Subject: Technical Memorandum, Beacon Solar Energy Project,
Pine Tree Creek, California City, Kern County
Streambed Alteration Notification 2008-0146-R4

# Interoffice Technical MEMORANDUM

**Subject:** Beacon Solar Energy Project, Pine Tree Creek, California City,  
Kern County

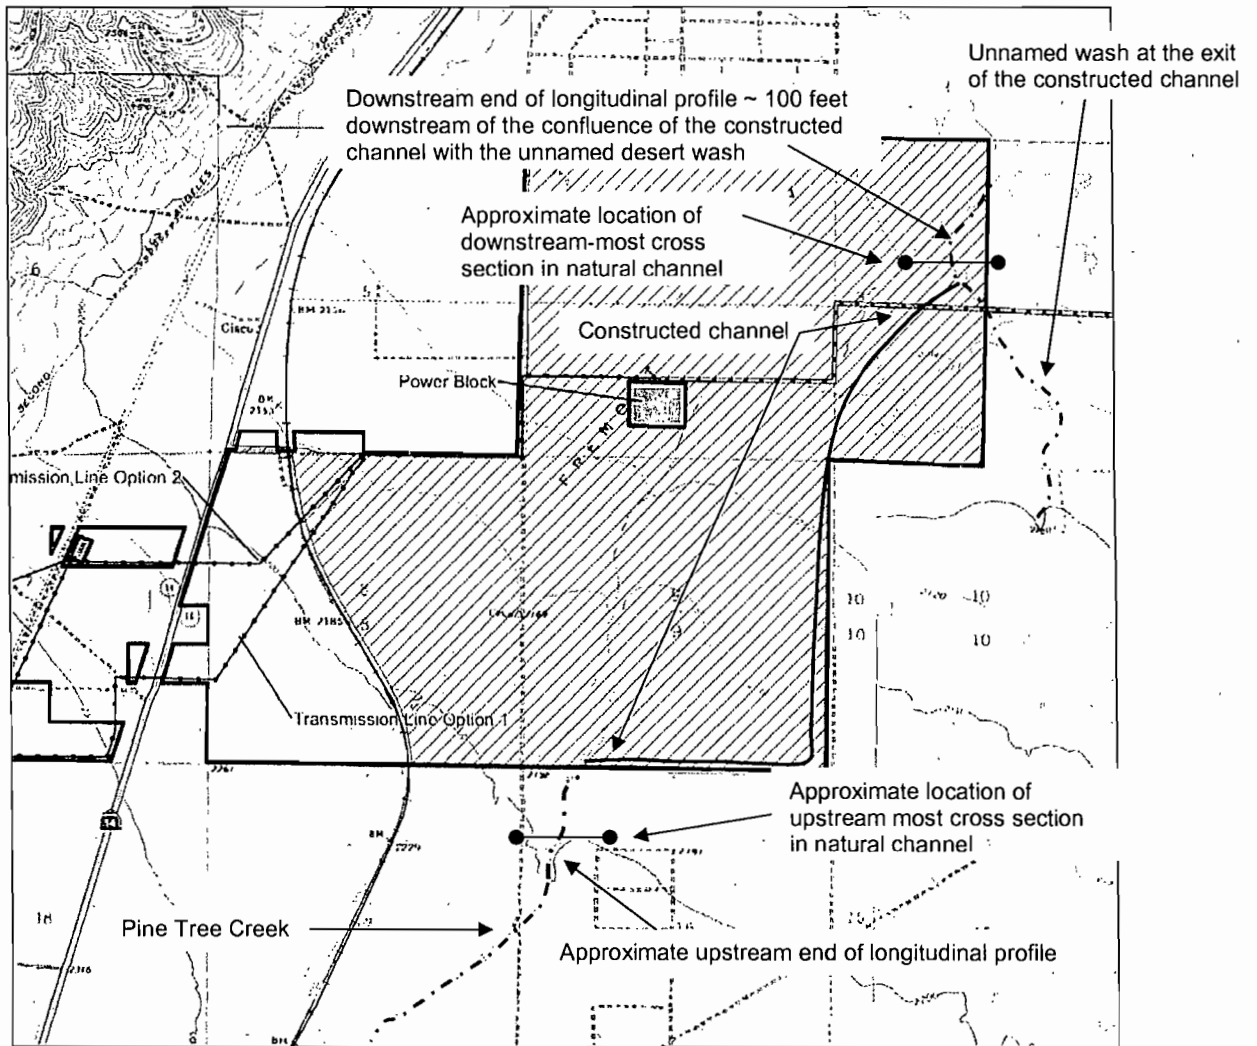
In addition to the corrections and additional hydraulic channel geometry detail noted above, the project proponent should also be asked to provide a longitudinal survey profile and two additional cross sections. The longitudinal profile should include the entire length of the constructed channel and the natural channel reaches most susceptible to project-induced erosion up- and downstream of the project. The profile should begin in the natural channel well upstream of the start of Turn 1, continue through the constructed channel, and extend downstream to the confluence of the

constructed channel with the desert wash that comes into the project area at the approximate mid-point of the eastern project boundary (Figure 1). This profile will provide the detail necessary to evaluate channel stability in these transitional areas, and will provide the baseline from which future project performance and mitigation effectiveness can be evaluated. The upstream-most cross section should be in the natural channel of Pine Tree Creek upstream of the entrance to the constructed channel; the downstream-most cross section should extend across the outlet of the constructed channel and completely span the unnamed desert wash near its confluence with the channel exit (Figure 1). These cross sections should be included in the revised hydraulic analysis provided for the project.
